**Attachment 4: Referral Responses**

Referral	Comments
Housing Officer	<p><b>Application Plans</b></p> <ul style="list-style-type: none"> <li>• The applicant seeks to provide both 6% affordable (8 units based on your calculations), and social housing on a ratio of 1 social housing units for every 8 private units to be provided above the density controls (4 units).</li> <li>• The affordable housing is targeted at moderate income households.. This is appropriate as affordable housing generally target moderate income households, in contrast with social housing which generally targets very low and low income households, and because the proposed affordable housing models of Shared Equity and Rent to Buy are suitable and affordable for moderate income households.</li> <li>• The affordable housing proposed is either (or both?) Shared Equity and Rent to Buy. There are some aspects that I am unclear of that I suggest should be clarified so that I can provide a more definitive response: <ul style="list-style-type: none"> <li>- Whether they propose both Shared Equity and Rent to Buy affordable housing?</li> <li>- Whether the Rent to Buy is related to the discussion of the PRADS model in the

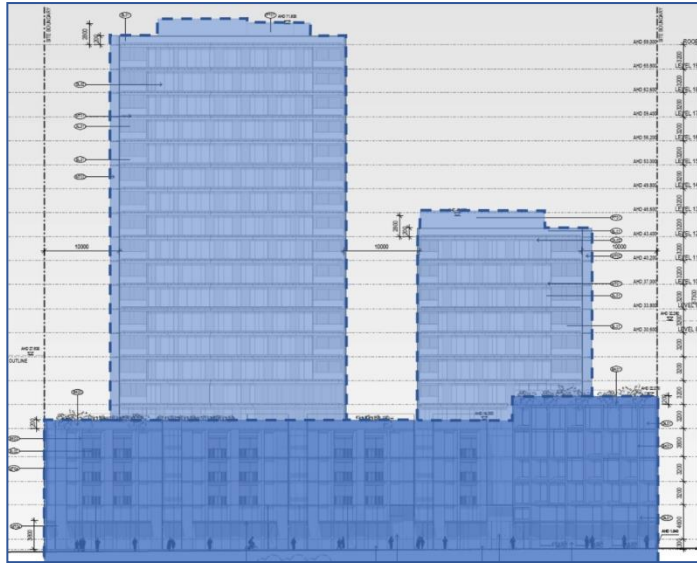
Another indicator of the apparent slenderness of a building would be the proportion of building mass along the site's frontage against the proportion of space / separation between buildings. The proposed towers take up 63% of the Buckhurst Street site frontage<sup>[3]</sup> (as illustrated by the diagram below – the towers have light blue shading and the podium has dark blue shading). This outcome is also evident in the architectural renders in the architectural plans (particularly Drawing Nos. TP08.01, 02, 04, 05, 10 and 12).

- (b) There is concern that the proposal will not "*limit impacts on the amenity of the public realm as a result of wind*". The amended wind assessment discussed in item 2 is required to respond to this matter.

It is recommended that the building envelope of the towers be reduced to present either the mid-rise development (i.e. 7-15 storeys) or the 'well-spaced slender tower' outcomes sought in DDO30. Further changes to the towers may be required to adequately manage wind impacts resulting from the development, subject to the amended wind assessment recommended in Item 3 below. This matter should be addressed through amended plans prior to a decision being made.

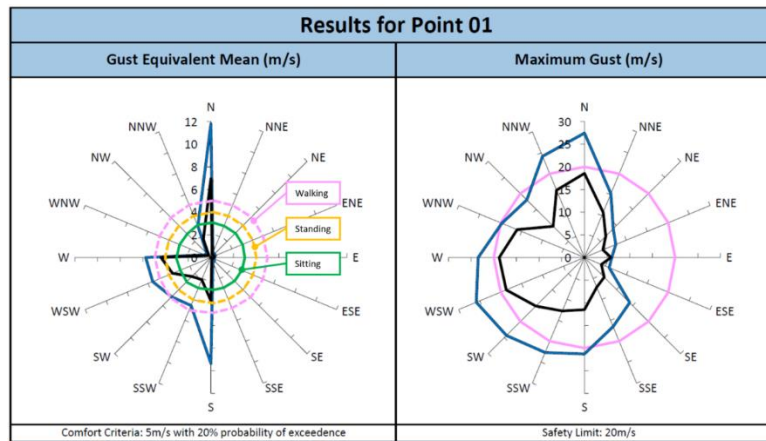
- (b) The assessment area shown in Figure 5a of the report does not align with the assessment distance required in Clause 2.11 of DDO30. An assessment distance of approximately 42m is required, based on half the longest width of the building. This area would include a greater extent of the pedestrian areas on Buckhurst Street (northern footpath and new linear park on southern side), George Street, Tates Place and the northeast portion of the new park on the corner of George and Thistlethwaite Streets.

- (c) The mandatory wind safety criteria in DDO30 must be achieved. Where the safety criterium is already exceeded, the development must not increase the extent of non-compliance. The current proposal results in exceedance or worsening of safety criteria in 3 test locations (# 1, 2 and 15);

- (d) The assessment criteria for pedestrian comfort need to be revised. The wind speed criteria used applies only to walking (5m/s) and not sitting or standing. As required in Clause 22.15-4.4, developments should contribute to a “*high quality public realm and deliver spaces, including open spaces, for people to meet, gather, socialise, exercise and relax*”. This outcome is particularly relevant for sites located in within the Montague Core Area (such as the subject site) where a “*high quality, high amenity public realm is to be delivered*” (Clause 21.06-8). Further, Buckhurst Street is to be “*a high amenity, linear green spine through the precinct*” (Clause 21.06-8). On this basis, the following areas within the assessment distance should meet the wind comfort criteria outlined in Clause 2.11 of DDO30:

The diagram below illustrates the different wind comfort criteria against the current directional plot for Point 01 (from Appendix C of the report). It indicates the extent of non-compliance with the DDO30 requirements and the level of intervention that may be required by the proposed development.

It is recommended that an amended wind assessment should be prepared that complies with the relevant planning scheme requirements. The required wind treatments will need to be incorporated into the proposal plans. It is preferred that this change be addressed through amended plans prior to a decision being made.

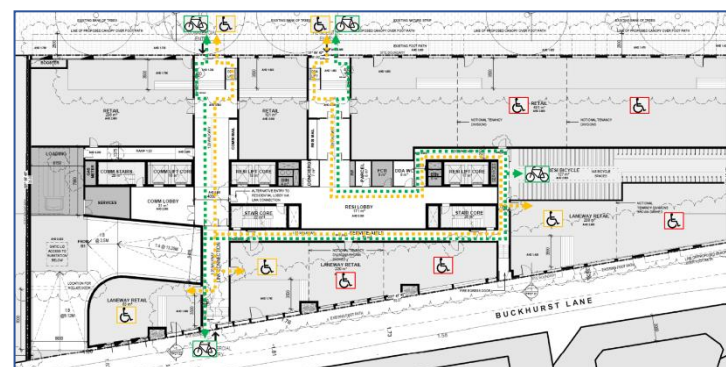
5. It is considered that the design outcomes for the **retail tenancies** fronting Buckhurst Street and Buckhurst Lane could be improved to better achieve the following development outcomes:

- Create activated building façades with windows and legible entries (Clause 2.12 of DDO30 – built form outcome);
- Encourage opportunity for social interaction at interfaces between the public and private realms (Clause 21.05-3); and
- Provide openable windows and balconies within the street wall along streets and laneways (Clause 2.12 of DDO30 – built form requirement).

- (a) Greater legibility of individual tenancy entries.
- (b) Provision of openable windows and balconies / outdoor seating areas along street frontages.
